Please see below comments in response to earlier comments by First Steps & Michael Eldred relating to a Basement Impact assessment report 13.032.3 prepared by Ecologia. The signatories to the report have responded thus:

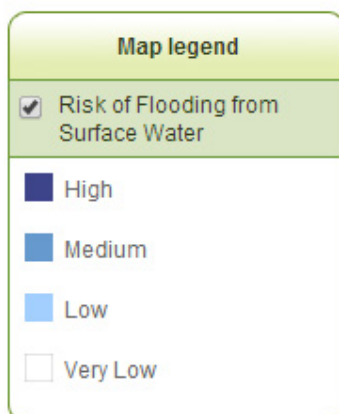
The Environment Agency published a new map of surface water flood modelling on its website earlier this year, formally called 'Risk of Flooding from Surface Water'. From work on other projects this map has generally been found to be the most detailed and plausible model currently available.

An enlarged extract of the map is presented below for the SHP area which shows no flooding (or to be precise 'Very Low' risk of flooding) in the rear gardens of any of the properties in the part of SHP of current interest.
